SERVICE LETTER

SUBJECT: FLAP MAINTENANCE ADAPTER CABLE

PILATUS Technical Memorandum (TM) - EC-12-TM-1196 (FCWU F329 Failures During Testing)

DRWN	01.03.09	G.Z.	PIL-MO	INDEX
APPD	01.03.09	APPD	01.03.09	APPD
DATE	01.03.09	DATE	01.03.09	DATE
SHEET 1 OF 1				27-52-00
ADAPTER CABLE FLAPS

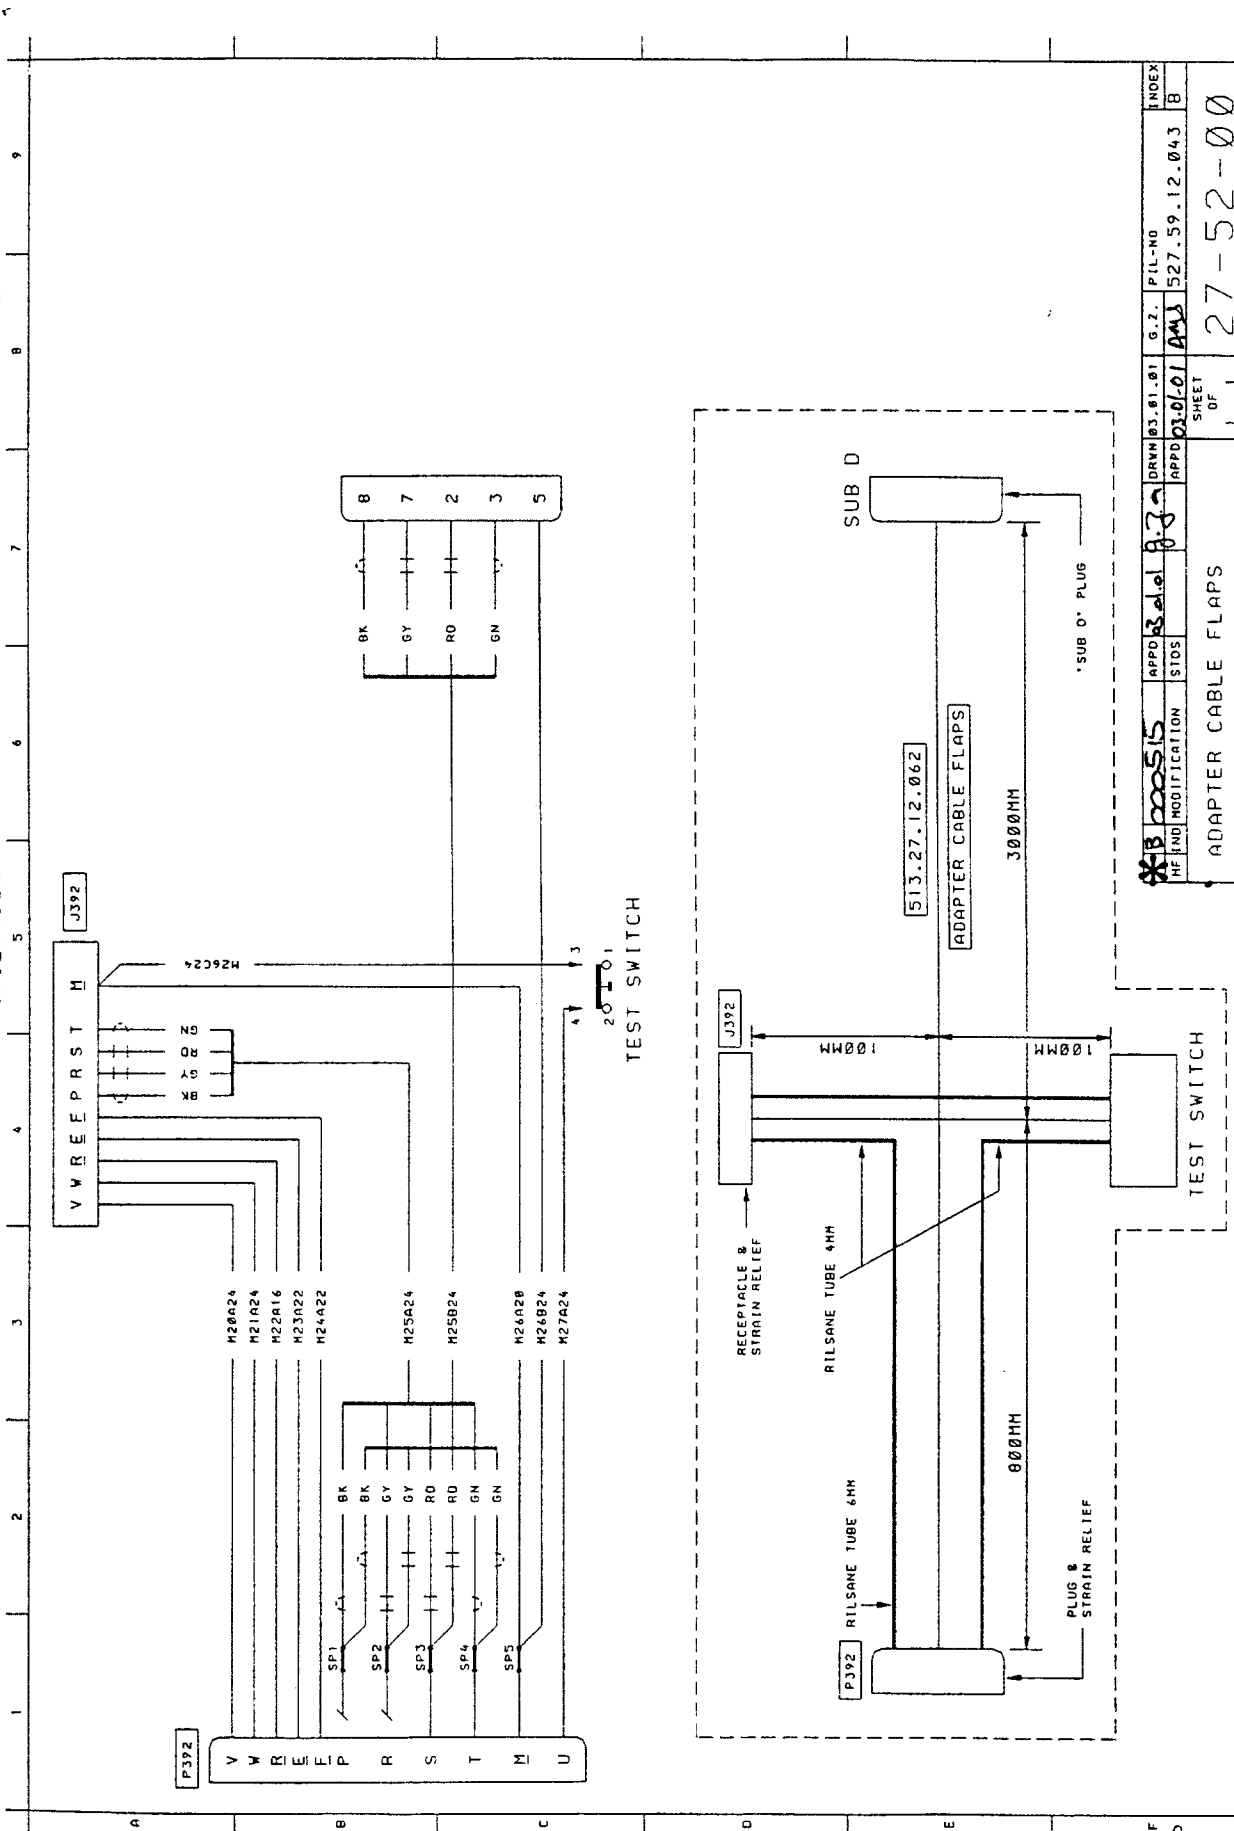
TM. EC-12-TM-1196 highlights the problems encountered when the Flap Maintenance Adapter Cable (P/N No. 513.27.12.062) is used during flap test procedures on Pre-series 9, PC-12/45 aircraft. The TM. also gives the data and instructions necessary to modify the cable.

Pilatus recommends the modification of the Flap Maintenance Adapter Cable because, when used, the FLAP RESET switch on the maintenance box will not function correctly.

<p align="center">MEMORANDUM TM</p>	<p align="center">EC-12-TM-1196</p>
PILATUS AIRCRAFT LTD STANS SWITZERLAND	<p align="center">M. Smith / ECA / Tel: 288</p>	<p align="center">24--12--00</p>
Subject: FCWU F329 FAILURES DURING TESTING		
<p><u>PROBLEM</u></p> <p>During the embodiment of SB27-008 and/or SB27-012, multiple F329 failure codes are being recorded on the Personal Computer (PC) monitor. The failure occurs when performing AMM 27-50-00 CONFIG 2 Section 3 - Flap System Set Procedure, Section 4 - Asymmetry Monitor Test or Section 5 Flap Twist Monitor Test. The failure results in the inability to Reset the flap system using the FLAP RESET SWITCH on the Maintenance Box.</p> <p><u>CAUSE</u></p> <p>The cause of this failure has been traced to a stray supply voltage generated by the PC entering the FCWU on the RS232 interface via the Maintenance Panel connector J392.</p> <p>This voltage appears on the RTS signal line and, because of coupling within the FCWU, interferes with the internal 5V power rail, preventing consistent power up resets.</p> <p>The problem occurs only on aircraft pre 9th Series as the 9th series aircraft have a different wiring configuration.</p> <p><u>SOLUTION</u></p> <p>As the FCWU / PC RS232 link is an asynchronous monitor, the RTS and CTS hardware handshake protocol is not used. Therefore these signal lines can be disconnected on the maintenance harness.</p> <p>As this is not an aircraft operational failure, it is necessary to modify the test equipment as follows:</p> <p>On APADTOR CABLE FLAPS (test cable harness) drawing number 527.59.12.043, disconnect wires M25B24 BK and M25B24 GY at connector P392 (Maintenance Panel Connector end).</p> <p>Refer to attached diagrams for details (Index A before; Index B after).</p>
